Access Compliance Report

Public Rights-of-Way

| Intersection ID: 50618 | Main Street: YELLOW_OAK_RD | Cross Street: ABNEY_CT | Location: | N |
| ADA ID: 4307B0228C28 | Ramp Type: Perp | Initial Pass/Fail: Pass | Overall Compliance: No | Severity Score: 0 |

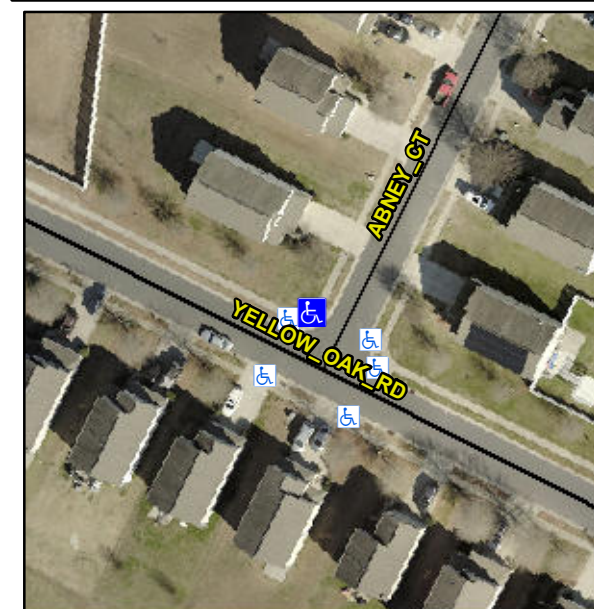
Not Found, R304.5.3, R305.2

| Compliance | Description | Data | Compliance | Description | Data |
|------------|-----------------------|--------|------------|-----------------------------|------|
| No | Landing X Slope (%) | 2.9 | Yes | DWS Full Width? | Yes |
| N/A | Landing Curb? (Y/N) | No | No | DWS Offset (in) | 6.5 |

Remove & Replace Entire Ramp.
